MARK	DATE	DESCRIPTIONS	BY	CH'D	CCO#
		REVISIONS			
2	01/31/07	WEST DEVIATION SADDLE GEOMETRY	AS	JD	15
1	07/21/06	W2 CAP BEAM ISD	JD	NV	23

SAN FRANCISCO OAKLAND BAY BRIDGE
EAST SPAN SEISMIC SAFETY PROJECT
SELF-ANCHORED SUSPENSION BRIDGE
(SUPERSTRUCTURE & TOWER)

W2 CAP BEAM DIMENSION DETAILS NO.6

WEST CABLE ANCHORAGE LAYOUT NO. 3

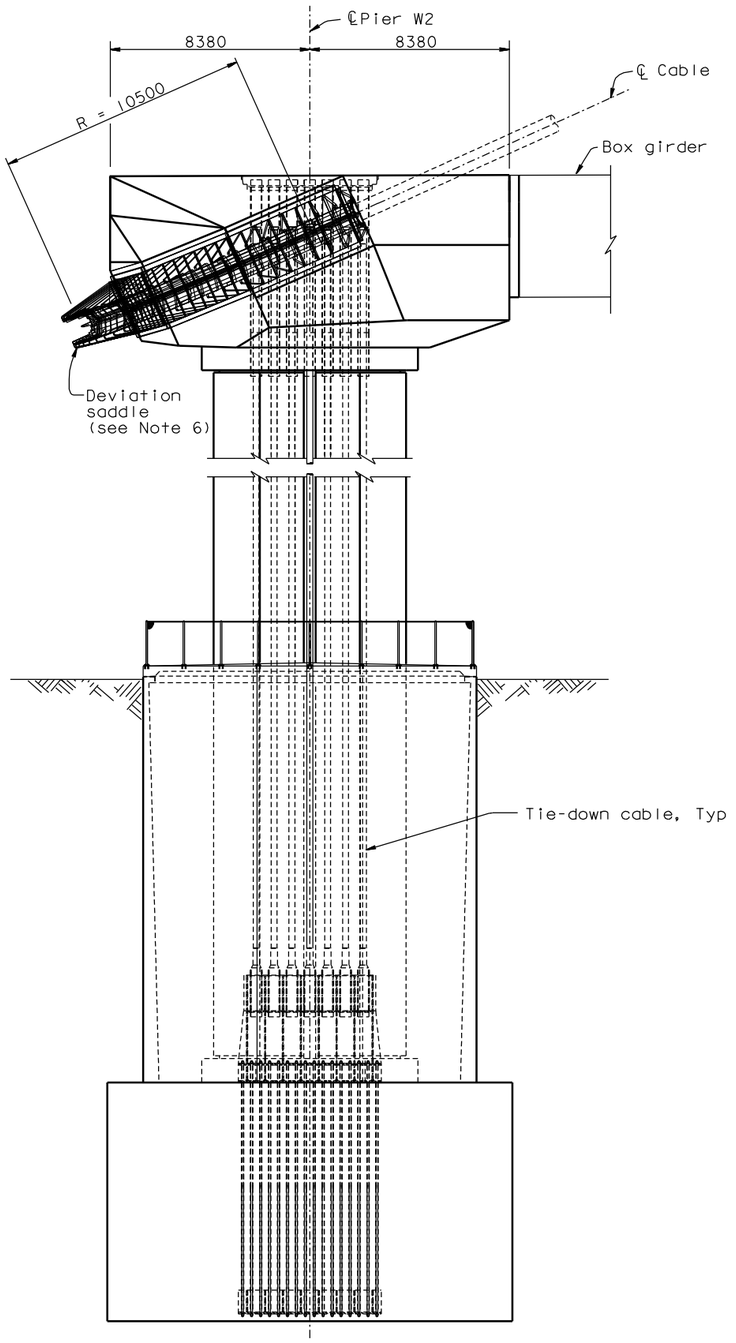
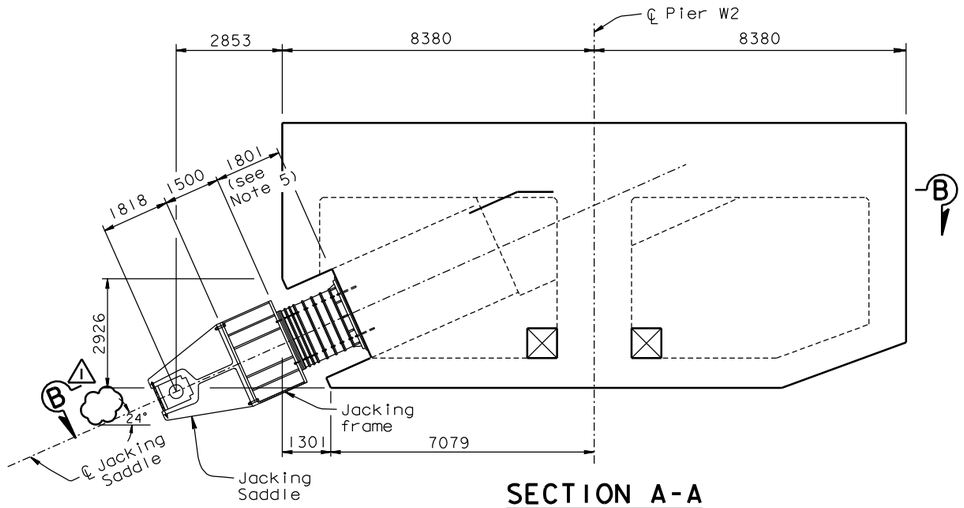
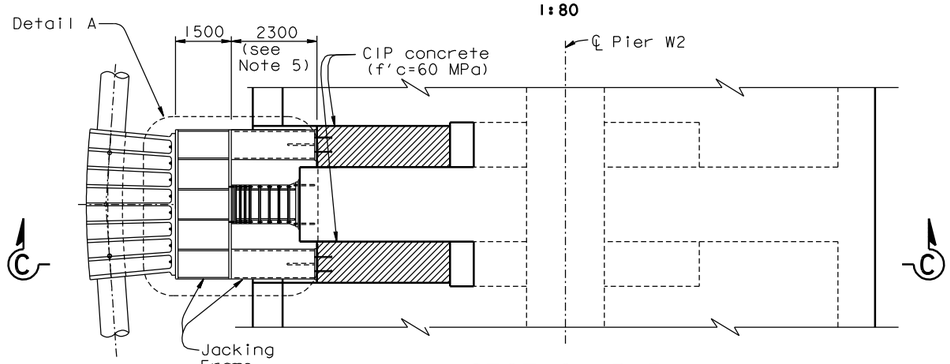
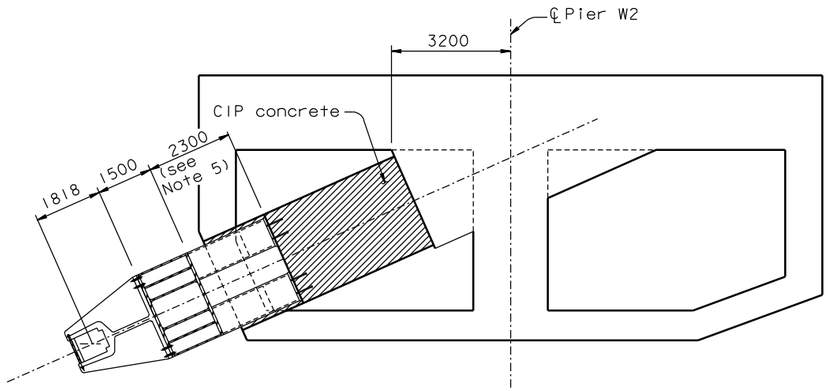
3 **REVISED PER ADDENDUM NO. 3 DATED NOVEMBER 7, 2005**

MARK	DATE	DESCRIPTIONS REVISIONS	BY	CH'D	CCO#
1	01/31/07	WEST DEVIATION SADDLE GEOMETRY	AS	JD	15

4. For Detail A, see "West Jacking Frame Details No.1" sheet.
3. This final position of the jacking saddle is for information only. This dimension will be revised by the Engineer based on the Contractor's final estimate of the suspended weight and the test results of the W2 cap beam concrete properties (elastic shortening, creep effects, shrinkage effects), to provide for equal forces on either side of the deviation saddle. This dimension will include an additional 44 mm to account for 25% of the maximum live load cable tension.

SUSPENSION CABLE LAYOUT NO. 3

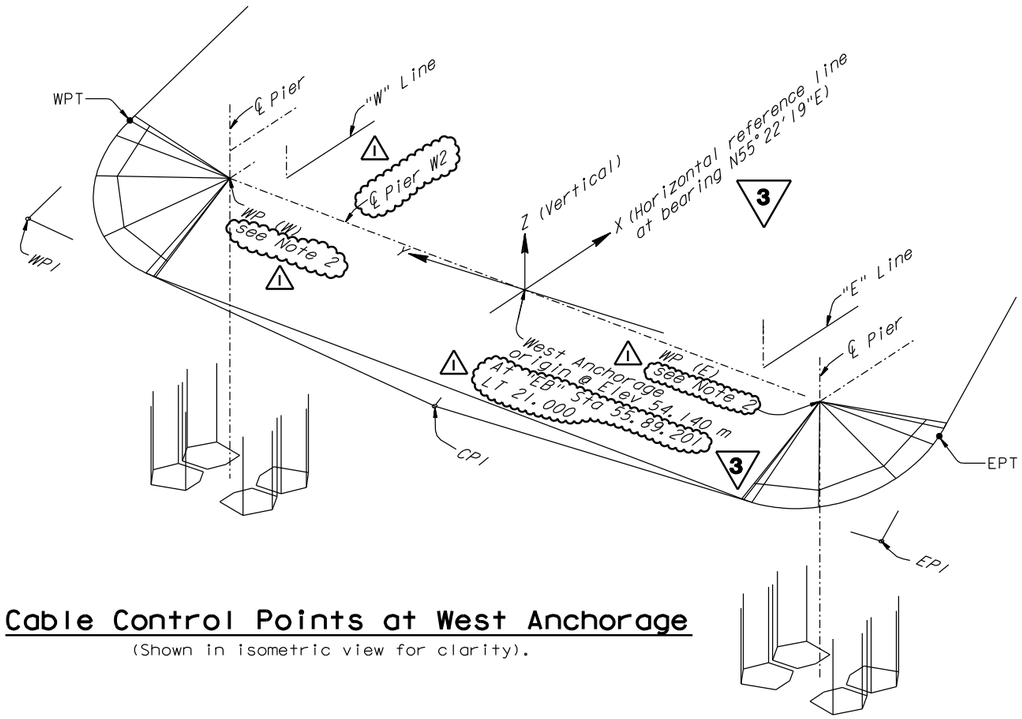
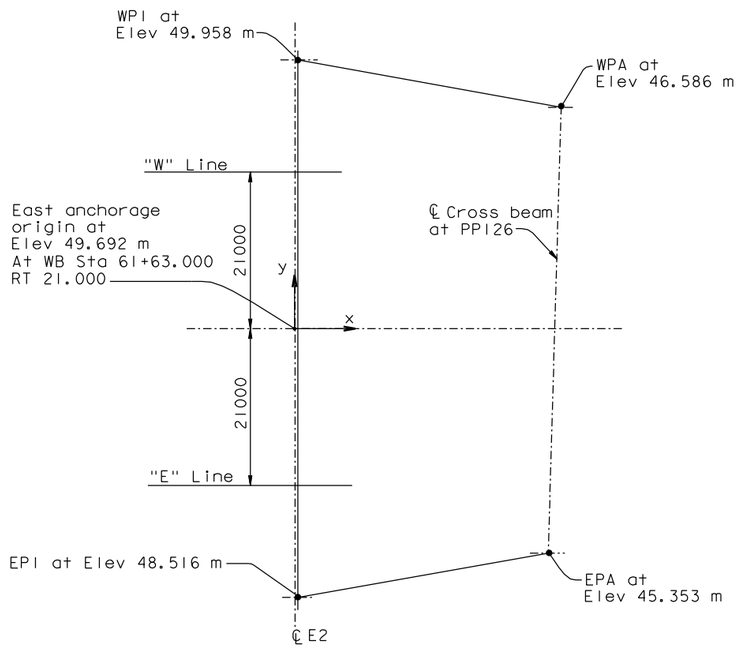
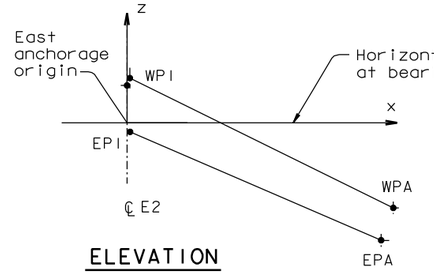
MARK	DATE	DESCRIPTIONS	BY	CH'D	CCO#
		REVISIONS			
1	01/31/07	WEST DEVIATION SADDLE GEOMETRY	AS	MN	15

3 **REVISED PER ADDENDUM NO. 3 DATED NOVEMBER 7, 2005**

1. At the west anchorage the cable profile shall be determined from the EPT and WPT. Geometry of saddles shall conform to EP1, WP1 and CP1.
1 2. WP(W) & WP(E) do not coincide with ℄ Pier W2, ℄ Pier W2E nor ℄ Pier W2W.

PLAN VIEW (In the plan of the Deviation saddle)
1:40
(South Deviation saddle shown
North Deviation saddle opposite hand, except as noted)

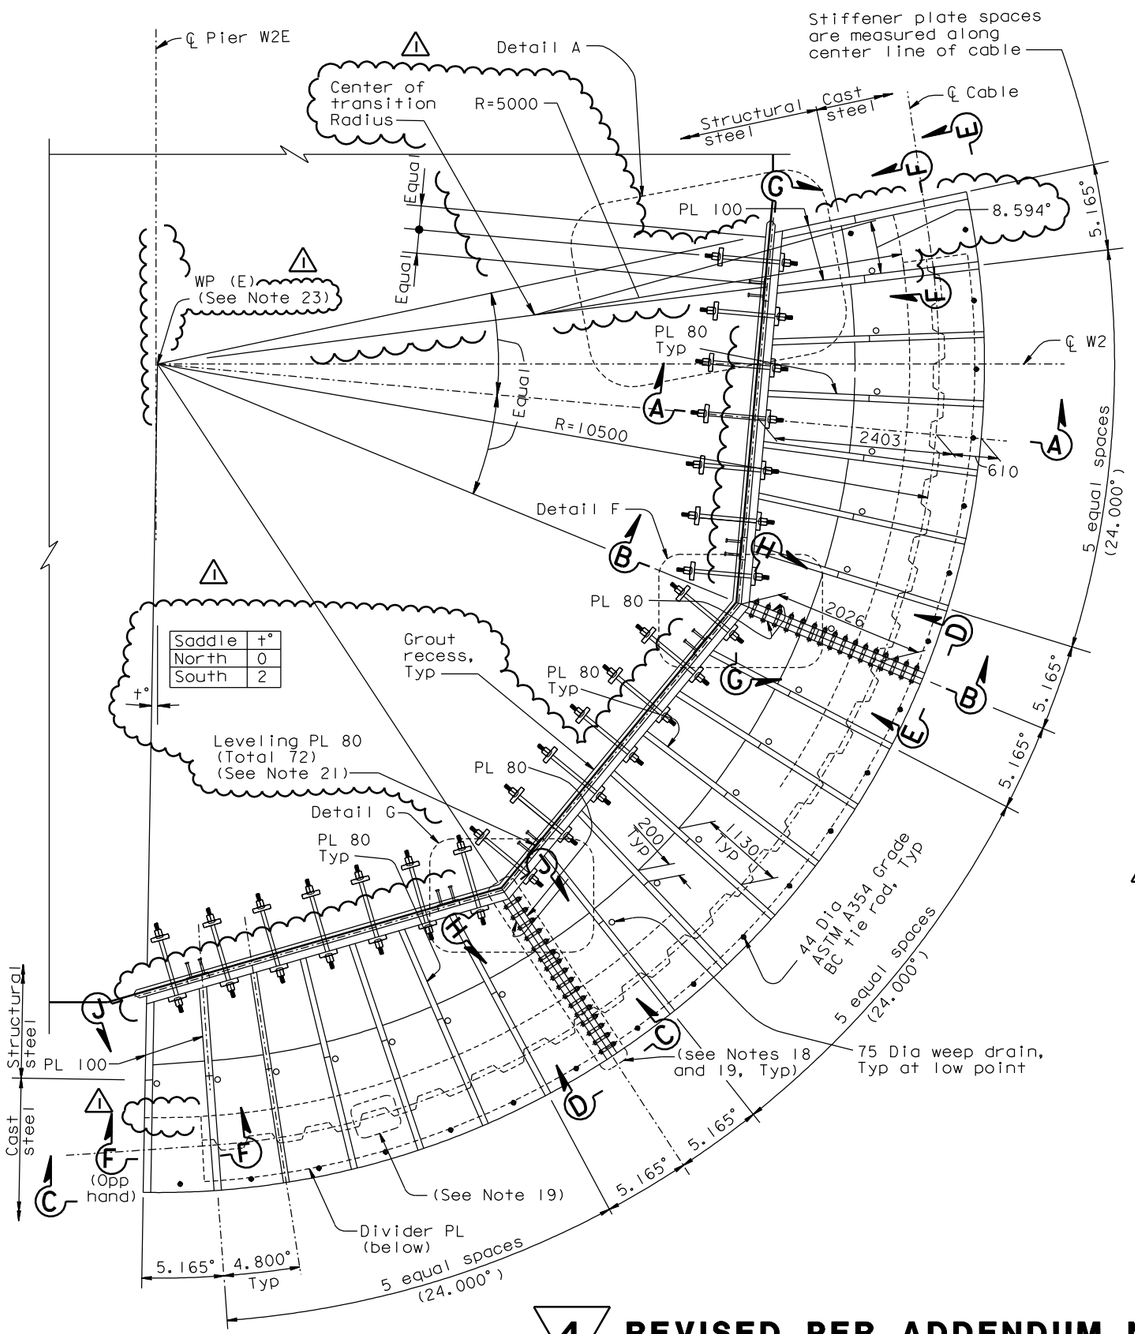
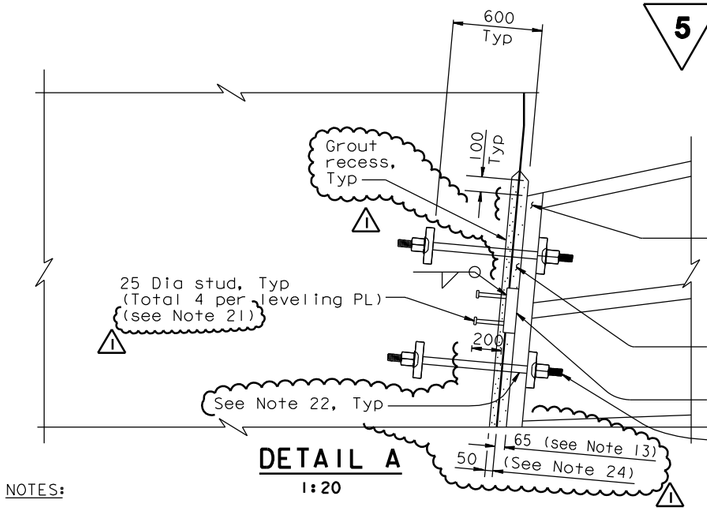
4 REVISED PER ADDENDUM NO. 4 DATED DECEMBER 9, 2005

5 REVISED PER ADDENDUM NO. 5 DATED DECEMBER 21, 2005

24. West deviation saddle grout recess shall be parallel to concrete faces of cap beam.

5 **SECTION B-B** (Anchor rods not shown for clarity)
1:20

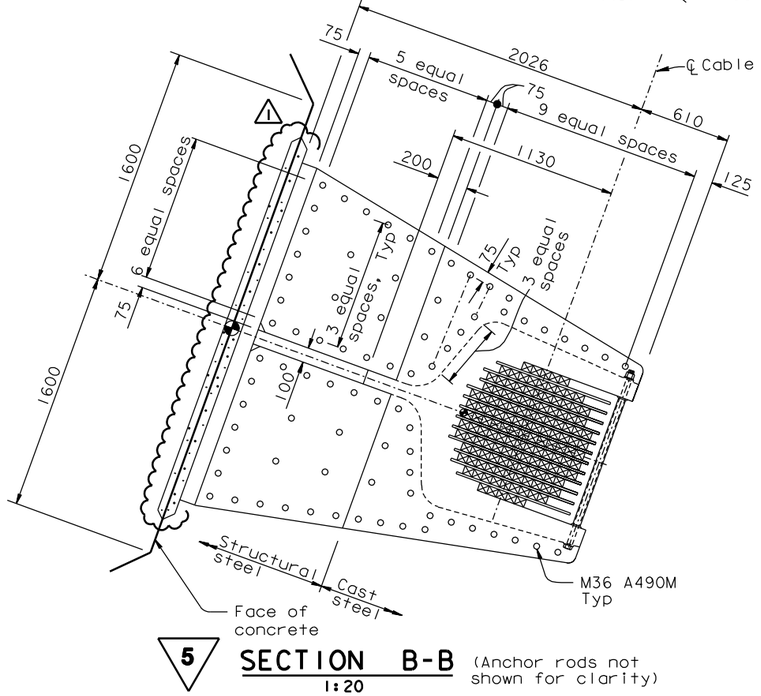
5 **REVISED PER ADDENDUM NO. 5 DATED DECEMBER 21, 2005**

5 **SECTION C-C**
1:25

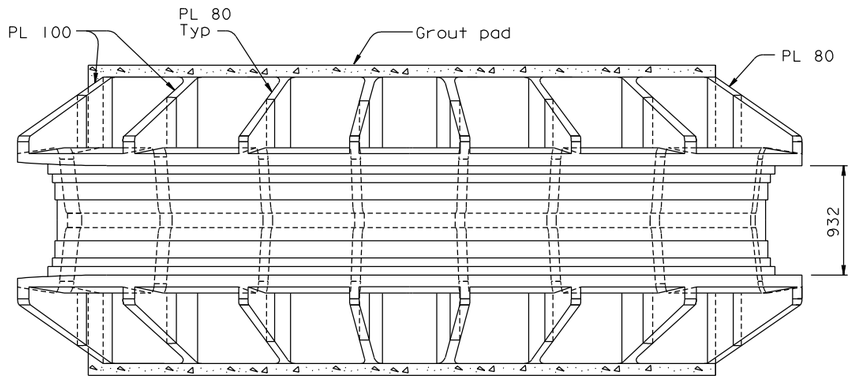
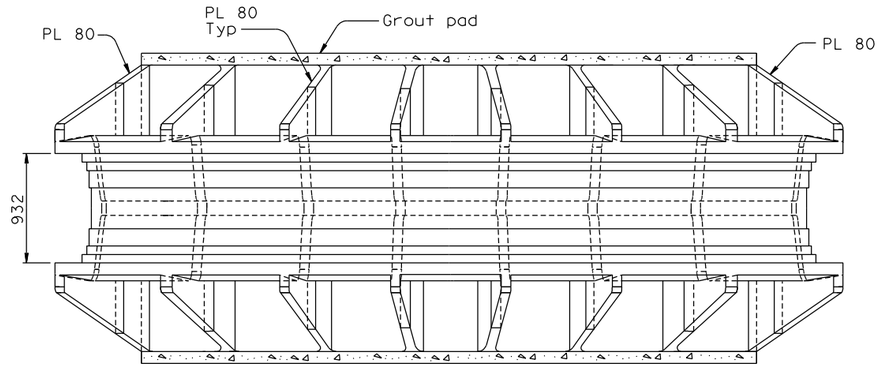
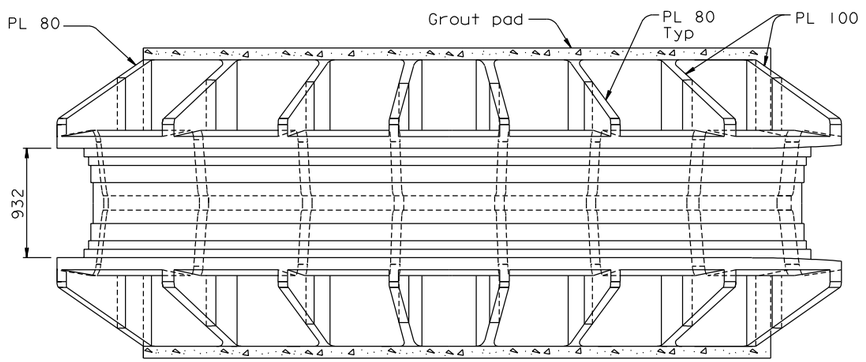
5 **REVISED PER ADDENDUM NO. 5 DATED DECEMBER 21, 2005**

5 DETAIL A
1:5

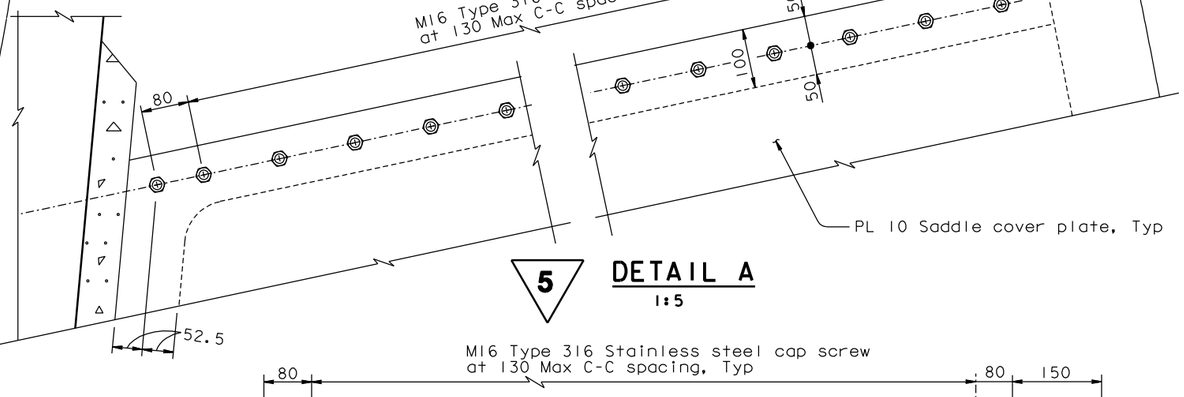
5 REVISED PER ADDENDUM NO. 5 DATED DECEMBER 21, 2005

5 SECTION G-G (Pipe beam anchorage) (see Note 3)

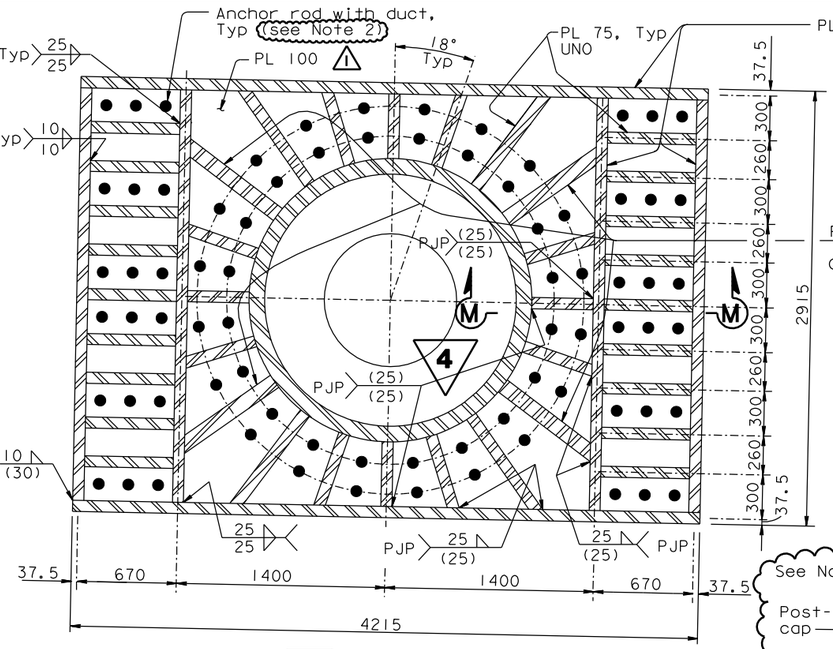
5 REVISED PER ADDENDUM NO. 5 DATED DECEMBER 21, 2005

Step 4

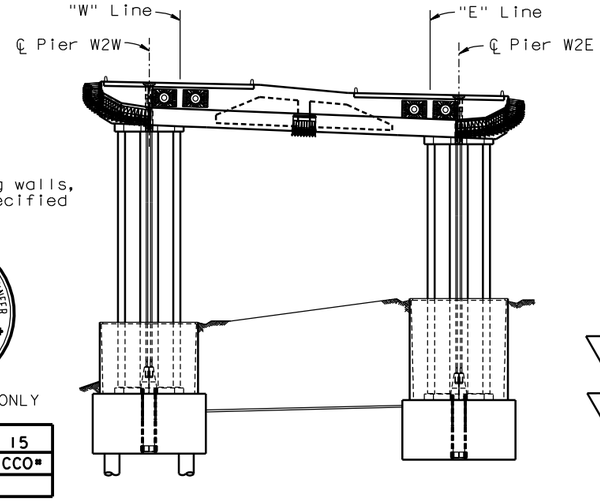
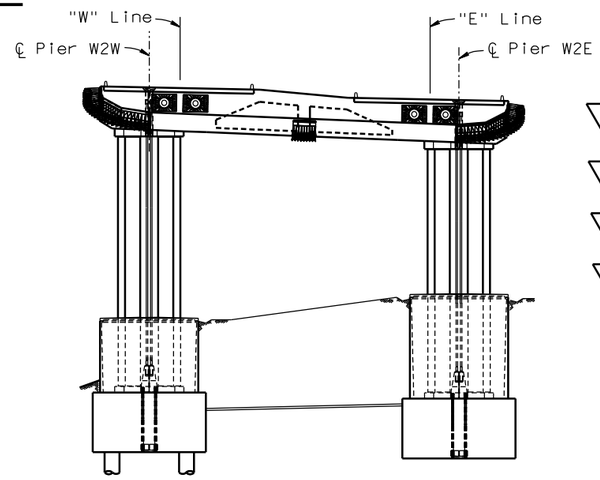
3 **REVISED PER ADDENDUM NO. 3 DATED NOVEMBER 7, 2005**

3 1. Install tie-down stay cables and stress specified design force.

3 2. Install Jacking Saddle.

3 1. Secure main span deck end segment and pour main span deck closure joint at cap beam.
